MONITORING YEAR 0 ANNUAL REPORT FINAL

LAUREL VALLEY MITIGATION SITE

SUBJECT: NCIRT Review and USACE Approval of the NCDMS Laurel Valley Mitigation Plan Addendum / Burke County/ SAW-2020-00053/ NCDMS Project # 100140

RE: Notice of Mitigation Plan Addendum Approval & Initial Credit Release
Laurel Valley Mitigation Site – Burke County
Catawba River Basin Cataloging Unit 03050101
DMS Project ID #100140
USACE ACTION ID SAW-2020-00053
DWR # 20200018

Figure 1a Current Condition Plan View
 Laurel Valley Mitigation Site
 DMS Project No. 100140
 Monitoring Year 0 - 2023
 Burke County, NC

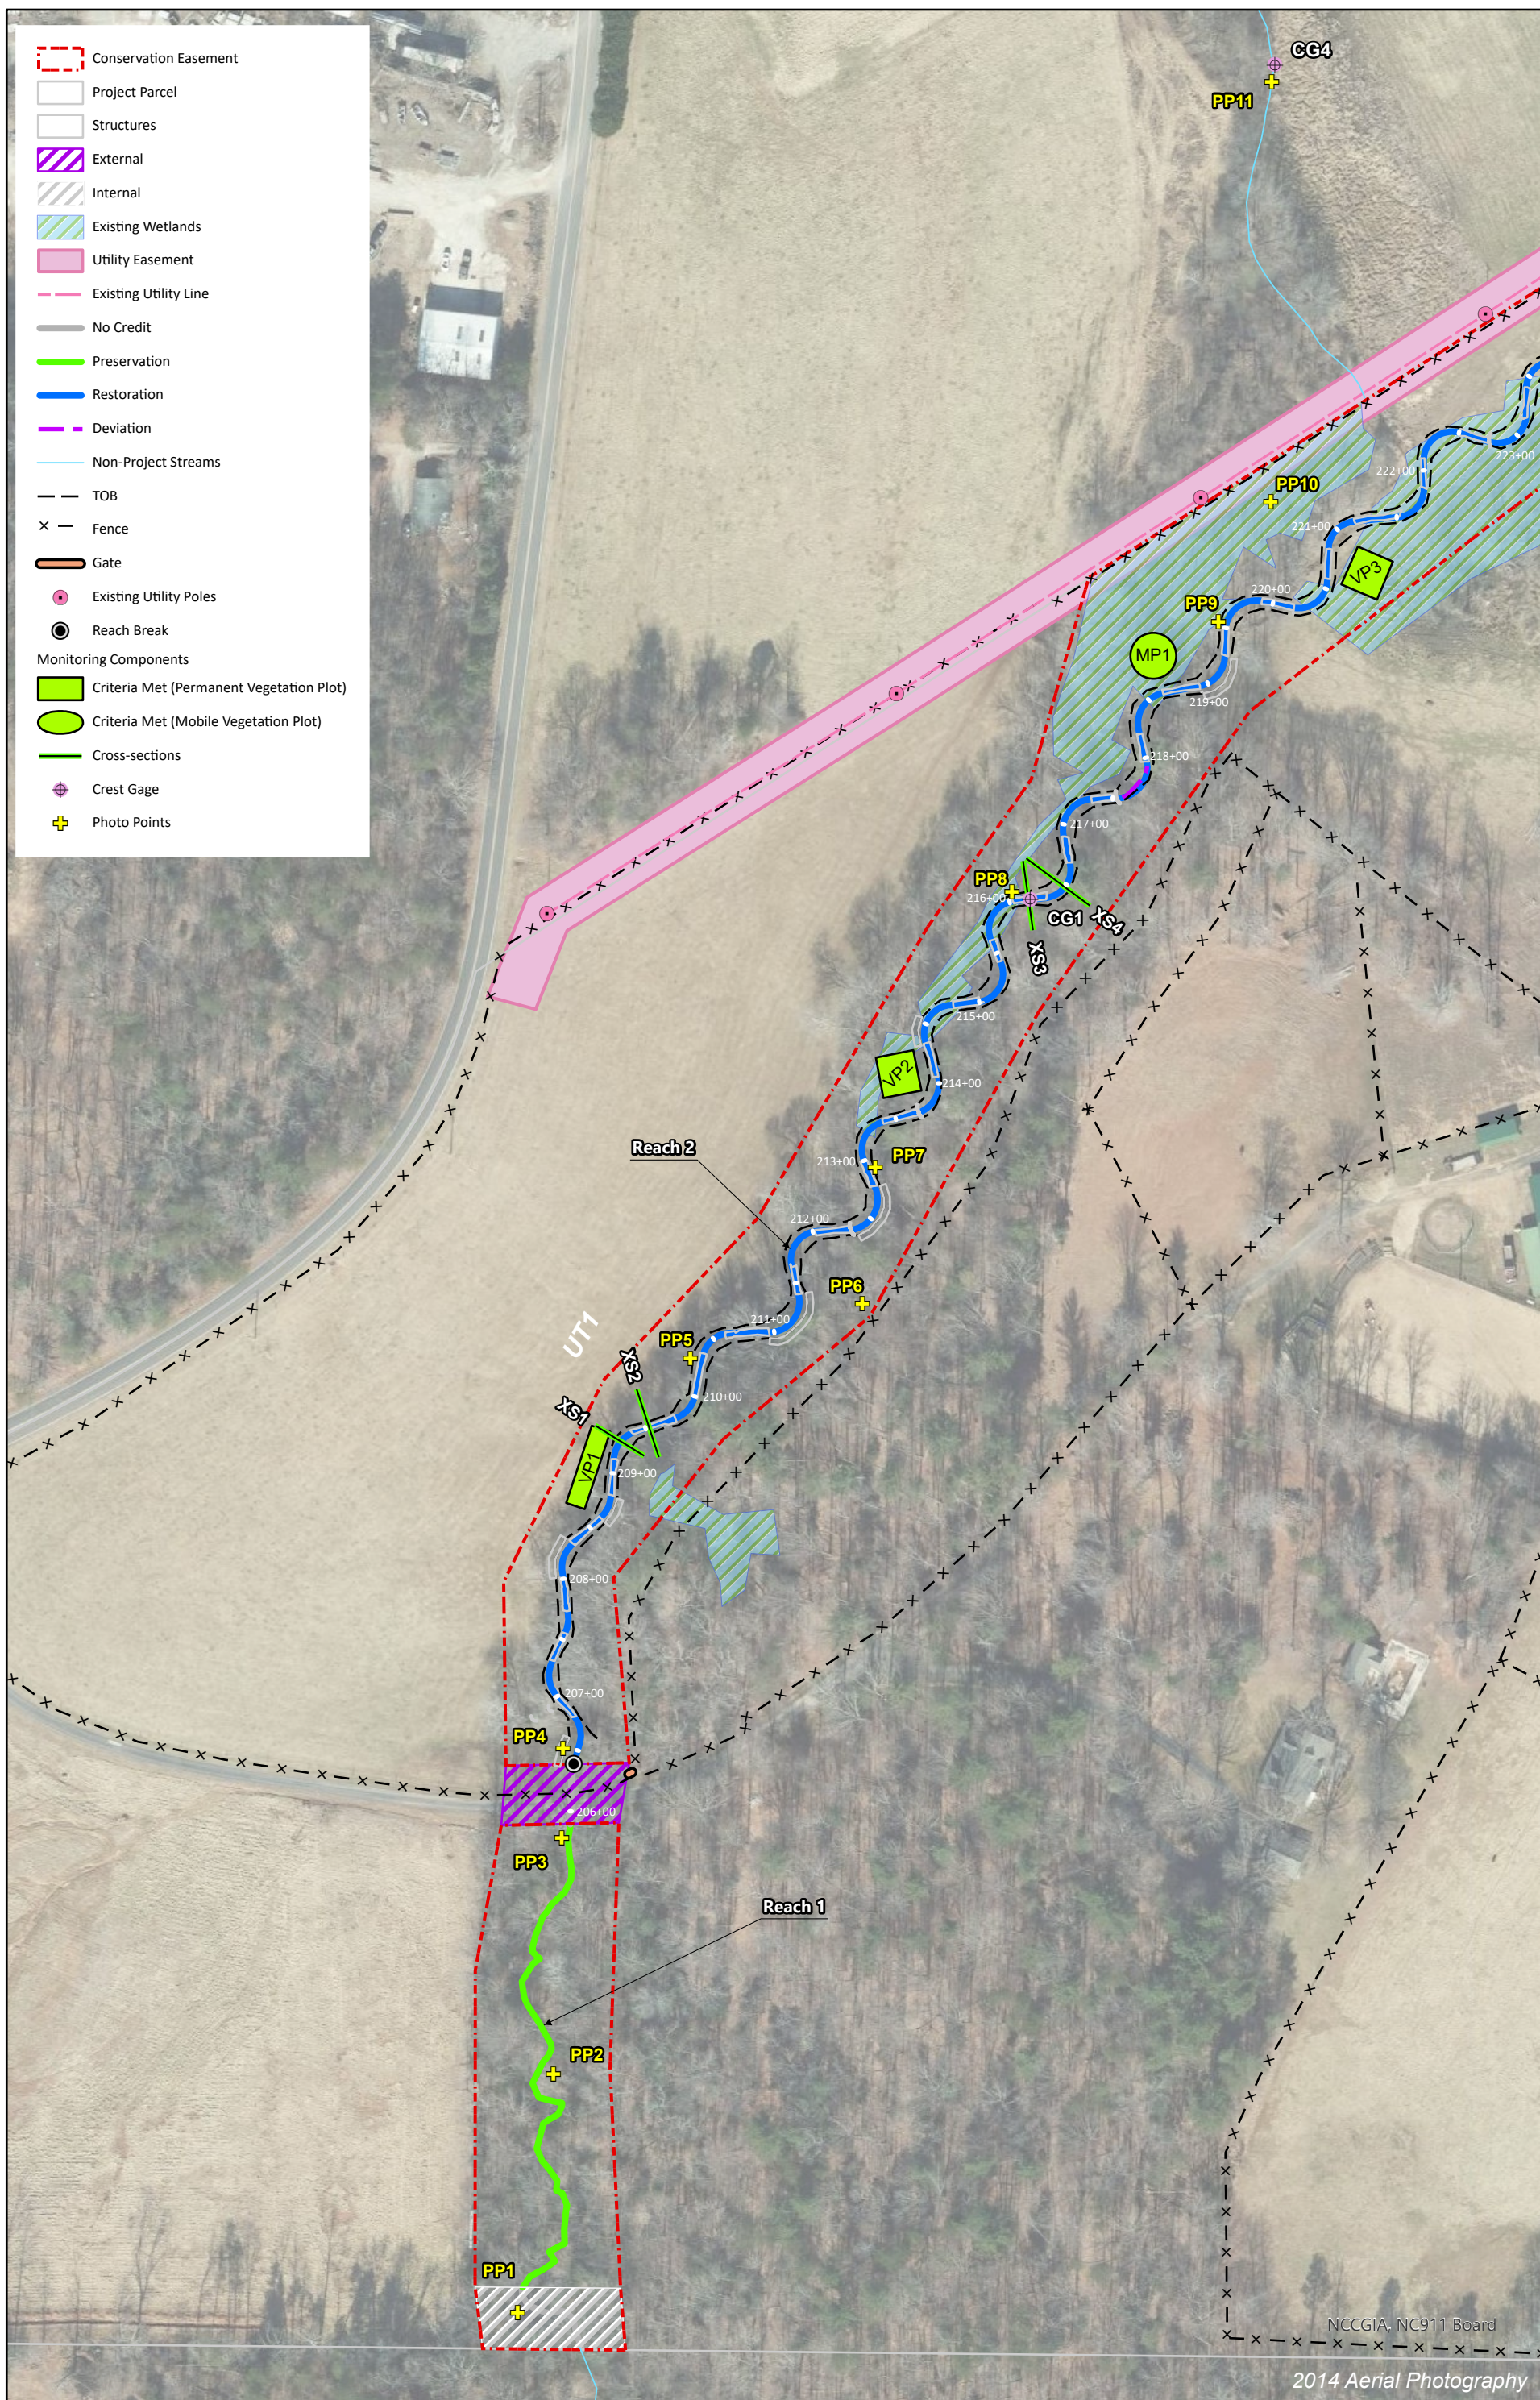
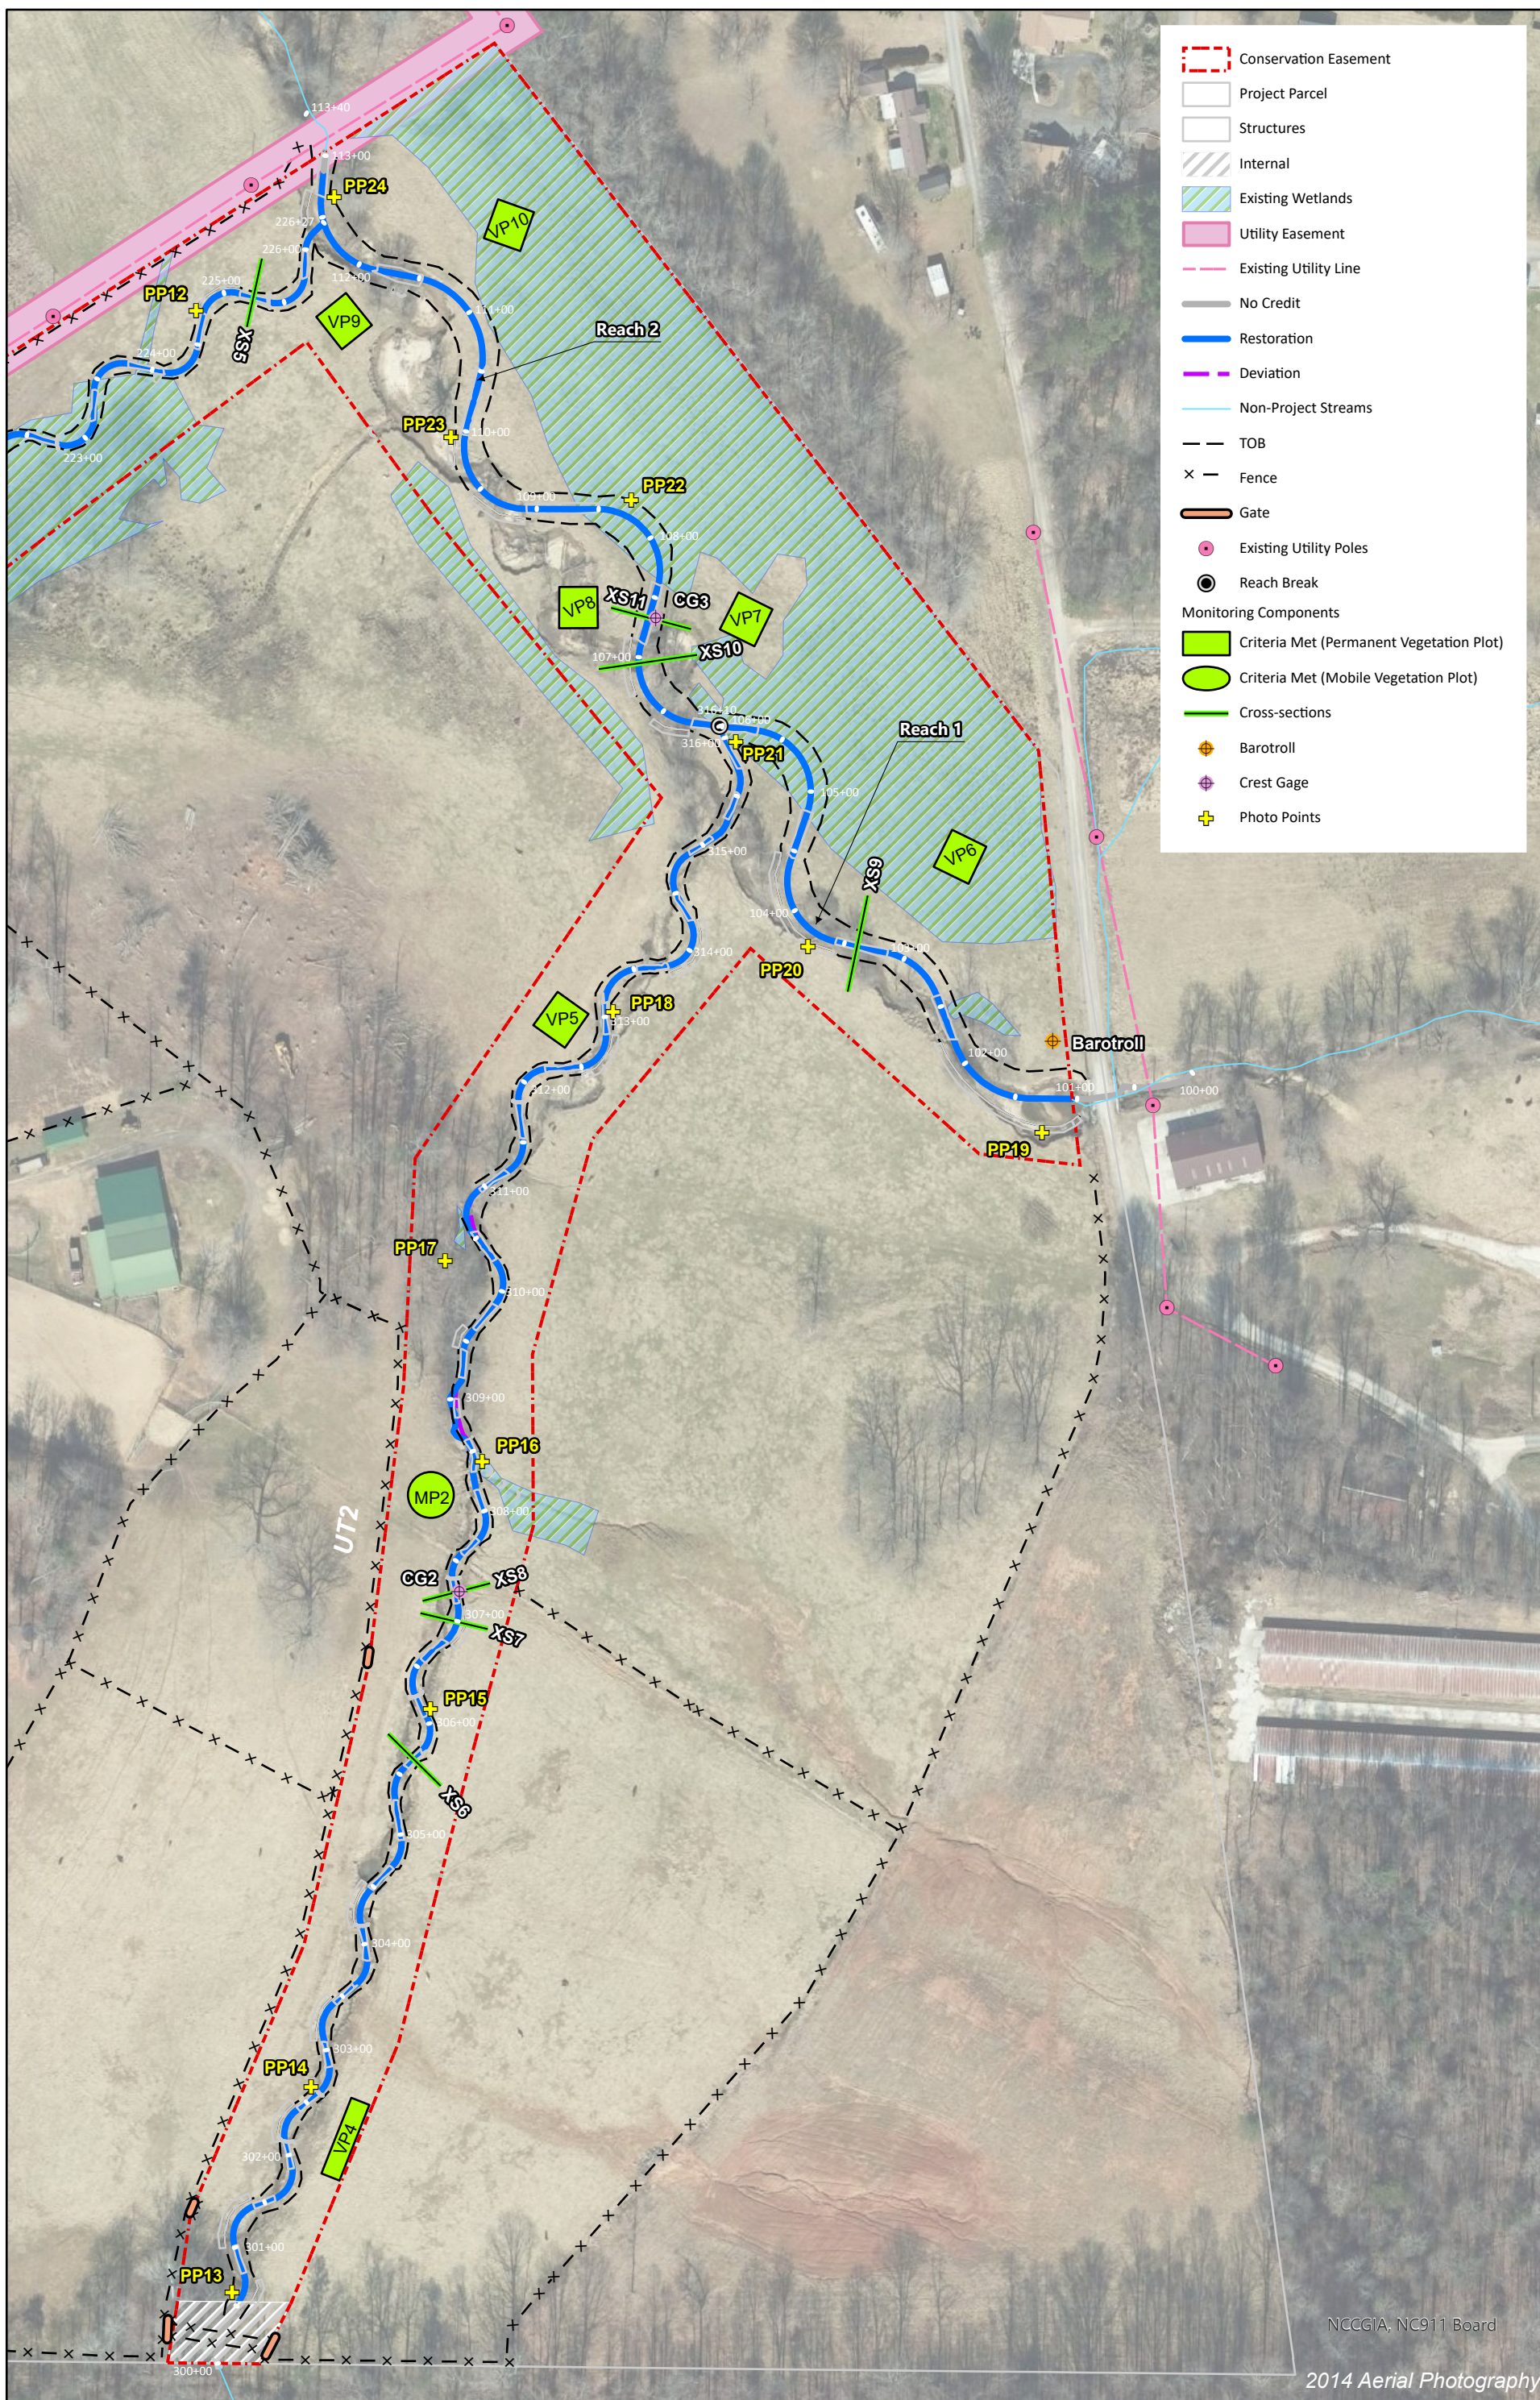
1. *Please remove the parking access symbols, or rename to “temporary parking location”, or similar as these are unplatted areas outside the conservation easement. Access or long-term permission should not be implied.*

Wildlands Response: The parking access symbols have been removed from CCPV maps.
